October 29, 2015
BOARD OF COUNTY COMMISSIONERS
ORANGE COUNTY, FLORIDA

ADDENDUM NO. 5
IFB NO. Y15-771 PH
ORANGE COUNTY SOUTH WATER RECLAMATION FACILITY
PHASE V IMPROVEMENTS

PROJECT NO.
180761
C-35
SHEET
89 OF 364

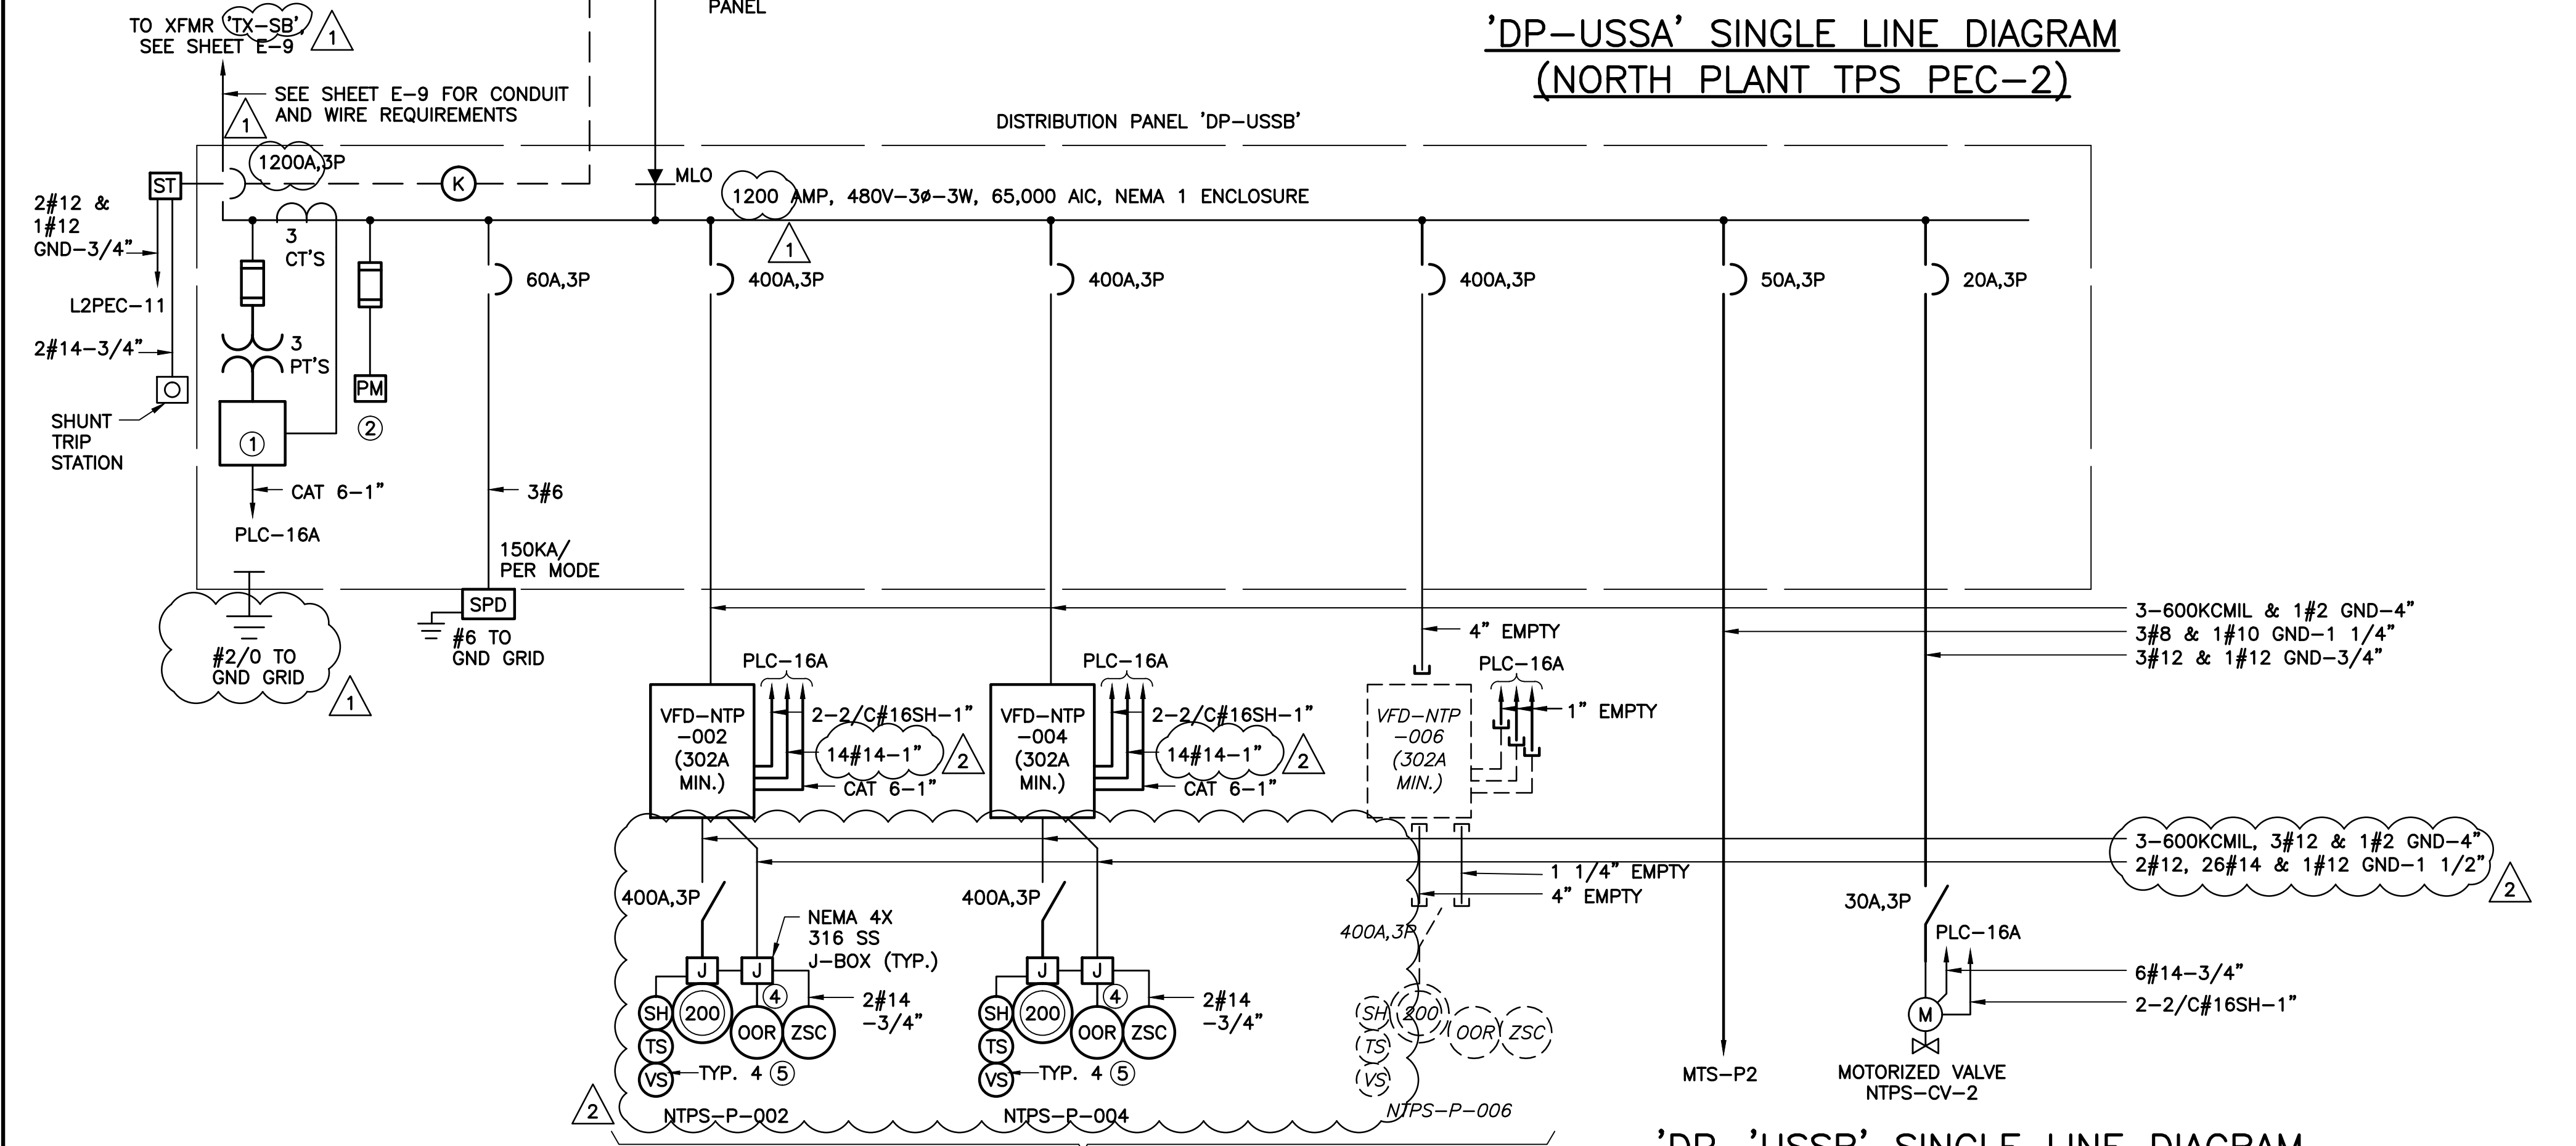
35. Sheet C-35 Section A, References Utility Note 32, and Spec Section 01143 1.5, j., please see below for comments:

Please reference Drawing C-35 (Attachment). Regarding this question the following specifications are revised as noted in Part B of this Addendum;

Please reference Drawing C-35 (Attachment). Regarding this question the following specifications are revised as noted in Part B of this Addendum;

PROJECT NO.
 180761
E-14
 SHEET
 233 OF 364

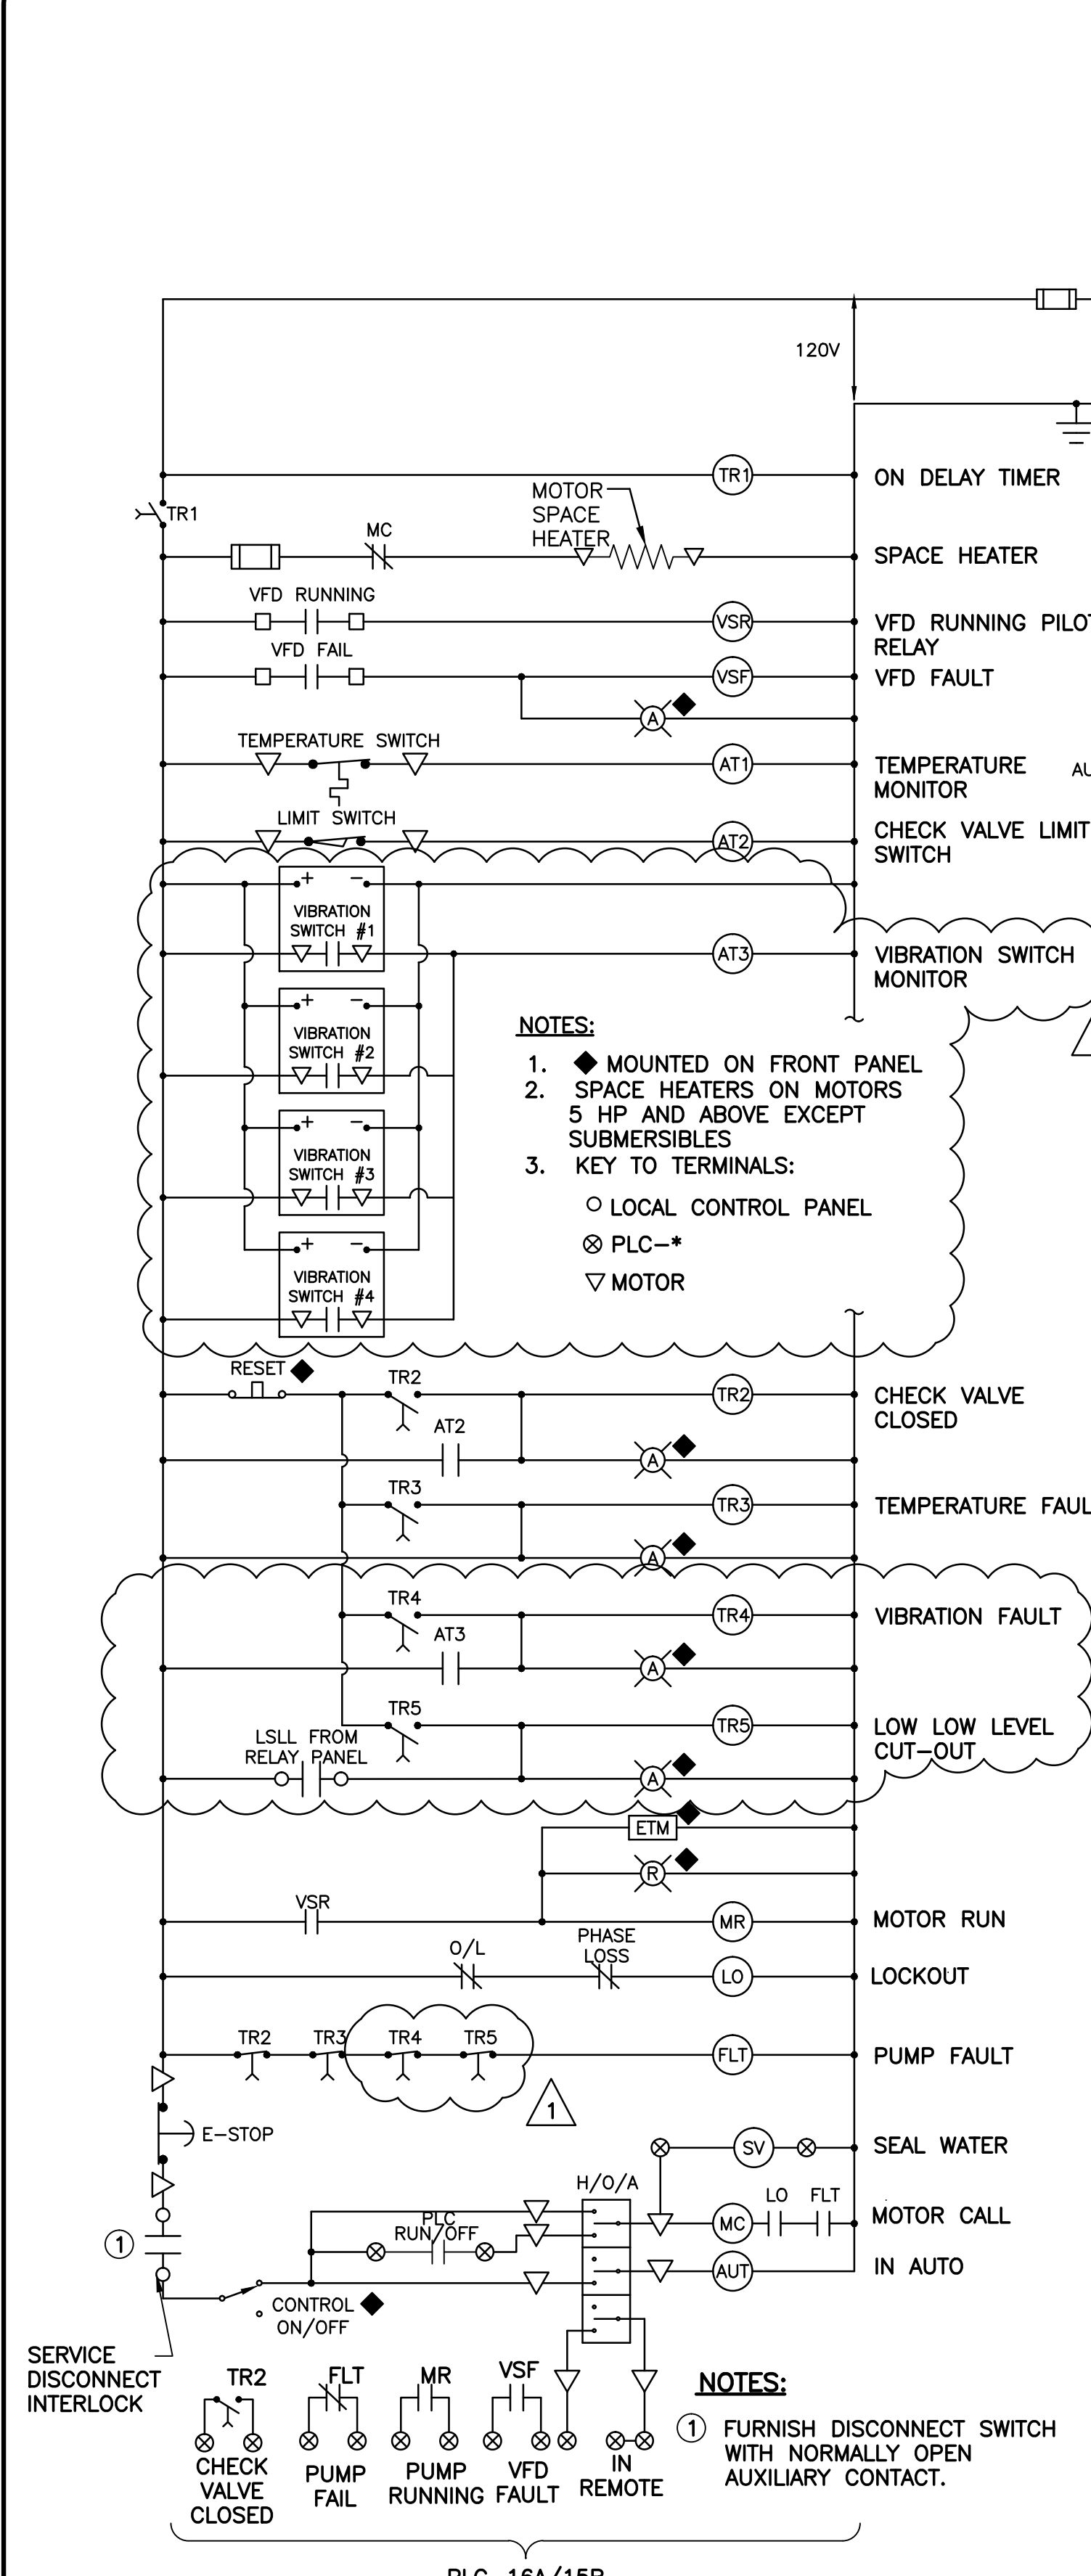
17. Sheet E-14: Replace Sheet E-14 in its entirety with the attached Sheet E-14 issued as part of this addendum.
18. Sheet E-46: Replace Sheet E-46 in its entirety with the attached Sheet E-46 issued as part of this addendum.
